US Route 2, Rural Major Collector. Bridge 32
Town of Richmond, Project BF 0284(28)

25'-0" x 5'-3" Rigid Frame Bridge
Approach Slab Layout and Details

DWG NO.
S3.4

1 S3.4 APPROACH SLAB PLAN VIEW
1/4" = 1'-0"

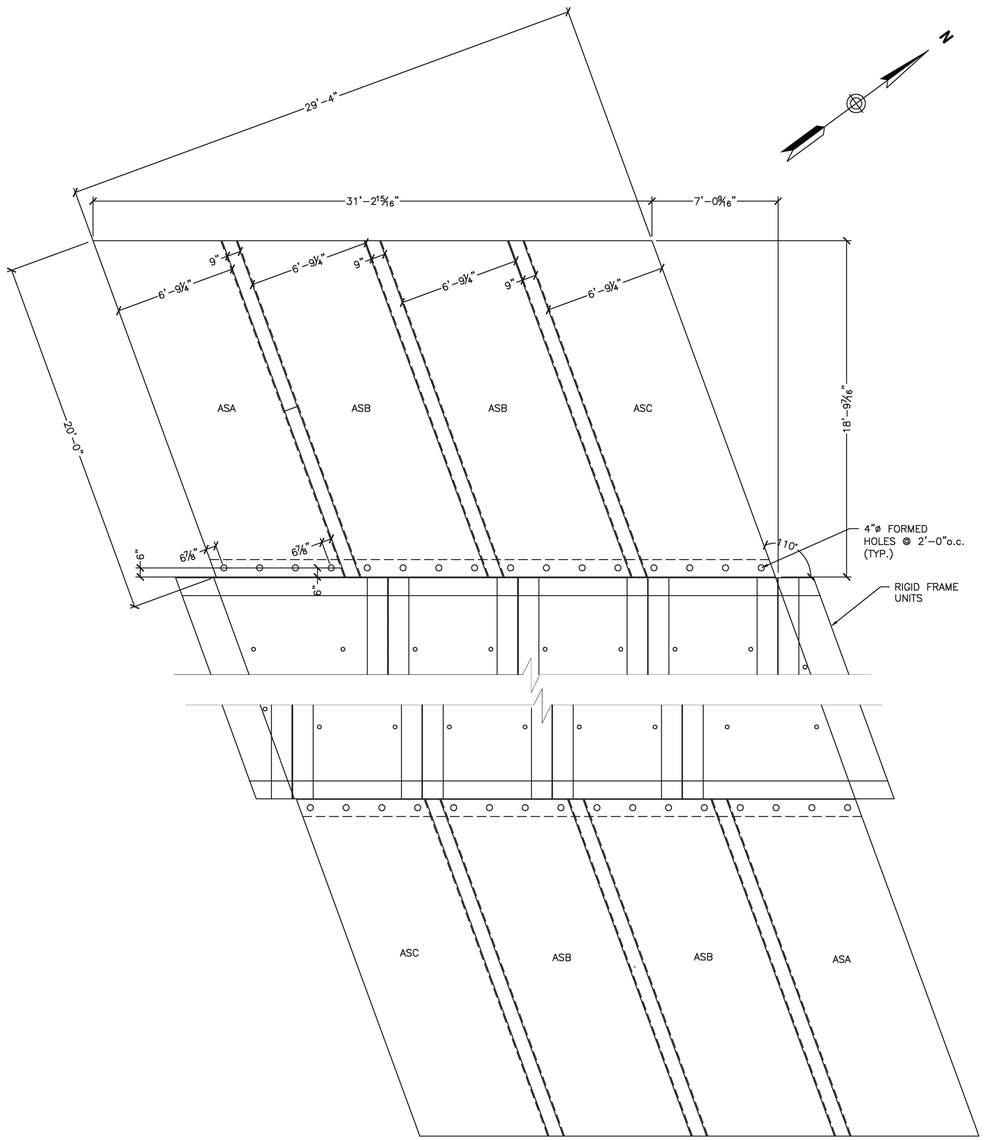
Contract plans sheet 3 note 34 says 1/8" exposed agg and indicate method used
